PLANNING, ZONING, & BUILDING DEPARTMENT
PZ&B Staff Combination Memorandum: Architectural Commission and Town Council

SUBJECT: ARC-23-121 (ZON-23-094) 428 SEABREEZE AVE (COMBO)

MEETING: SEPTEMBER 27, 2023 | ARCOM
OCTOBER 11, 2023 | TOWN COUNCIL

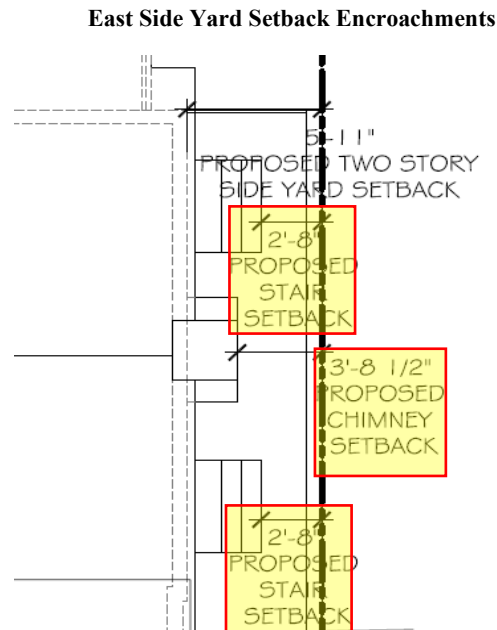
Code [Sec. 134-895](#) provides typical exceptions to yard regulations for architectural and egress features for residences within the R-B zoning district. Modest setback encroachment provisions are provided for architectural elements - such as chimneys, balconies, and bay windows, and for egress means - such as entry steps and landings, but Criteria 3 establishes an “absolute minimum” setback of 5’-0” - therefore typical encroachment exceptions are prohibited.

Additionally, the Sea Streets redevelopment provisions – as applied in this application - allow for side yard setbacks that are substantially smaller than what would be permitted under R-B zoning provisions with typical permitted exceptions.

Therefore, the applicant has applied for **Variance 1**, to permit the stair and chimney encroachments into the minimum 5’-0” setback:

Code Section	Required	Proposed	Variance
Variance 1: Sec. 134-893(a)(3)	Minimum 5’-0” East Side Yard Setback	Construct (2) Stairs with a 2’-8” East Side Yard Setback	2’-4” East Side Yard Setback Reduction
		Construct Chimney with a 3’-8 ½” East Side Yard Setback	1’- 3 ½” East Side Yard Setback Reduction

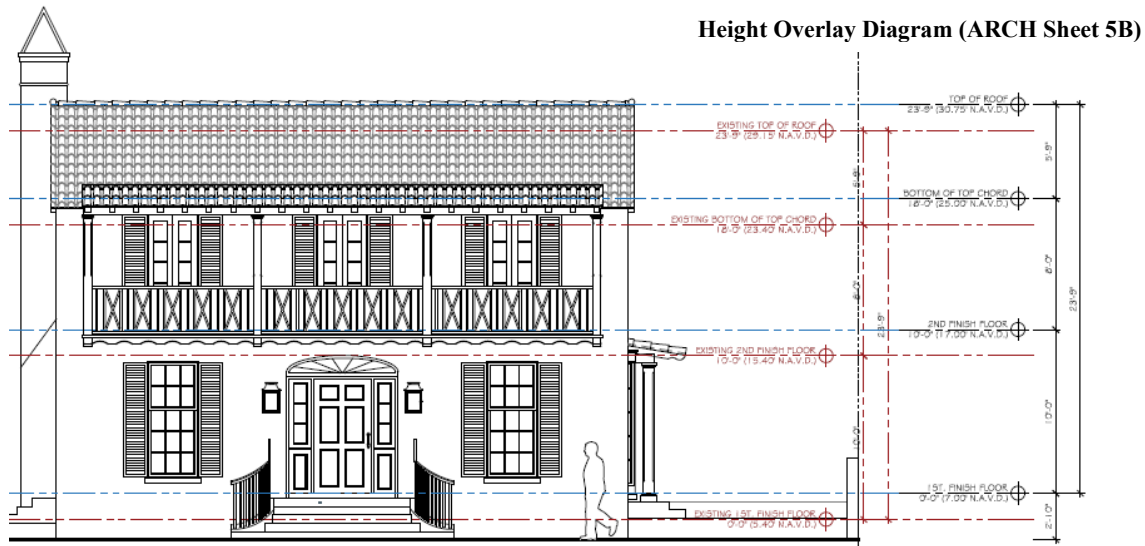
Analysis: The parcel lies within Flood Zone AE6, which requires new construction to build at a Finish Floor Elevation of 7’ NAVD, thus establishing the point of measurement at 7’ NAVD. The existing residence has a Finish Floor Elevation of 5.4’ NAVD.

A height overlay diagram provided on sheet 5B illustrates the points of measurement, building height (exterior wall height), and overall height (building height) for the existing and proposed residences. Per the graphic, the proposed residence’s height and overall height are proportionally the same as the existing residence when measured from their respective points of measurement:
